Building Manager: [Anthony Conrath, anthony.conrath@oregonstate.edu](mailto:anthony.conrath@oregonstate.edu)  
 Assessment Date: 2/9/2022  
 Assessment Number: **10539**  
 Location: Goss Stadium Entire  
 Reinspection date:

A joint fire safety inspection of the facility listed above was performed by the Environmental Health & Safety - Fire and Life Safety and the Corvallis Fire Department. These fire safety deficiencies could result in a fire or jeopardize the safety of those occupying the facility. Please see that these items are corrected immediately and no later than the scheduled reinspection date noted with this report. If you have any questions regarding this inspection, please email Brian Lilley (EH&S - Fire and Life Safety) at [brian.lilley@oregonstate.edu](mailto:brian.lilley@oregonstate.edu).

Near Casey Corner

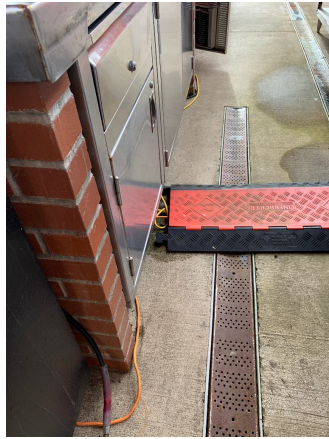
Priority code	Standard in need of attention	Reg.Reference	Location	Resp	Observations & Recommendations	Date Corrected
2	Extension cords and flexible cords shall not be a substitute for permanent wiring.	2019 OFC 604.5	Various:Throughout	DEPT	Discontinue use of extension cords in place of permanent wiring:  Near Casey Corner  New batting cages
